MIL-C-60181(MU)
AMENDMENT 3
25 March 1968
SUPERSEDING
AMENDMENT 2
10 October 1967

MILITARY SPECIFICATION

CONTAINER, SHIPPING, REUSABLE: 10539223

This amendment forms a part of Military Specification MIL-C-60181(MU), dated 2 March 1965.

FIGURE 1- CASE ASSEMBLY

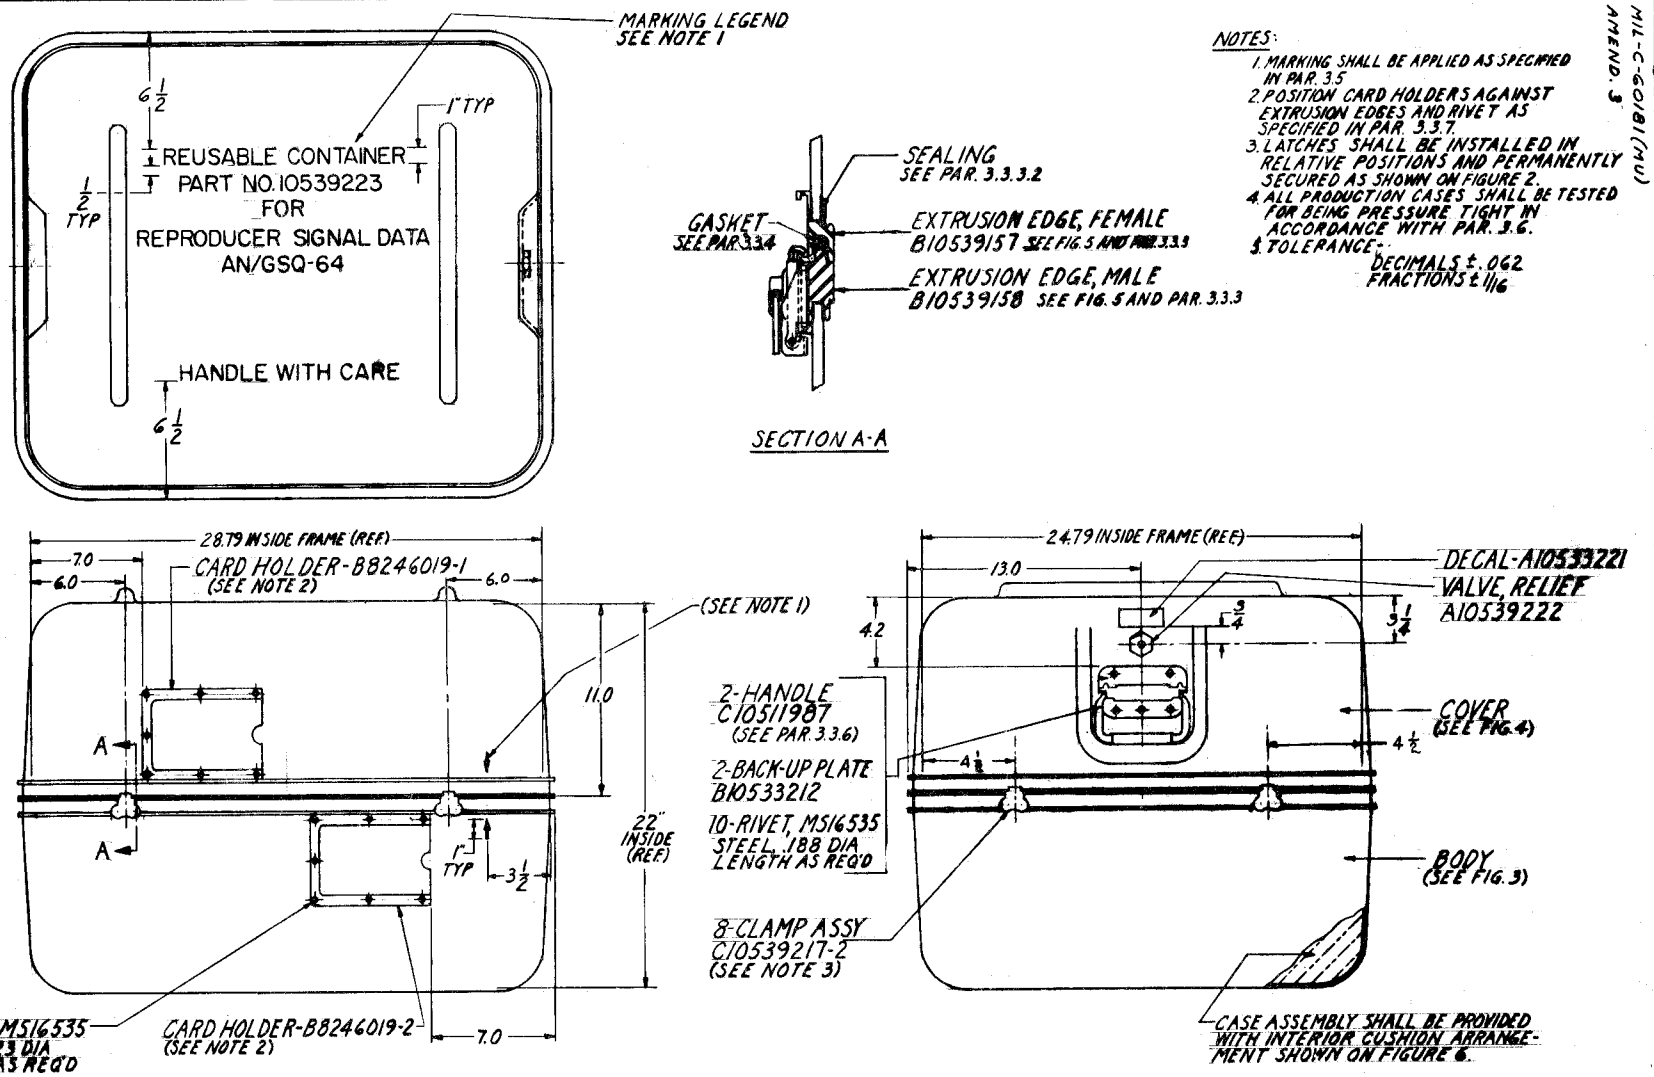
* Delete: "Figures 1, 3 and 4" and substitute attached "Figures 1, 3 and 4."
